## SERVICE BULLETIN

B-075 Safety Recall Code 0834

#### 2008 1125R TRANSMISSION JET RECALL

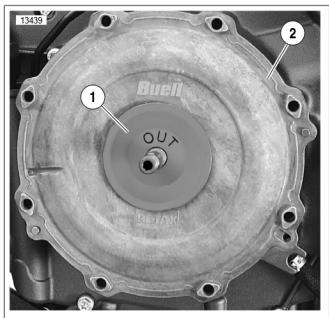
See Figure 12. If oil jet has already been installed as a result of efforts by Buell Racing Support, proceed to step 18.

- See Figure 12. Install oil jet (2) into clutch shaft (1) until oil jet is flush with end of clutch shaft.
- Clean oil jet with compressed air and make sure nozzle
   is not blocked.
- 18. See Figure 13. Fit the stepped washers and fasteners to the springs and install the pressure plate and springs.
- Install the springs in a cross pattern until the fasteners bottom
- Tighten the fasteners to 89 in-lbs (10 Nm).
- See Figure 14. Verify that the two needle pins (1) are in place in the clutch cover.
- 22. Install the diaphragm cover gasket (2).
- See Figure 7. Apply LUBRIPLATE No. 105 Motor Assembly Grease to the bore of the inner clutch diaphragm cover (2).
- Fit the diaphragm cover with the embossed BUELL side out.
- 25. Install inner disc plate (1) with side stamped "OUT" facing away from engine.

Figure 10. Oil Jet

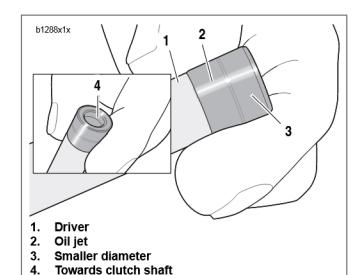
See Figure 10. Apply 2-3 drops of LOCTITE 648 (green) or equivalent onto the smaller outside diameter (3) of the oil jet.

See Figure 10. To install oil jet (2), use a driver (1) that has a larger diameter than the oil jet. The smaller diameter (3) of oil jet faces clutch shaft.
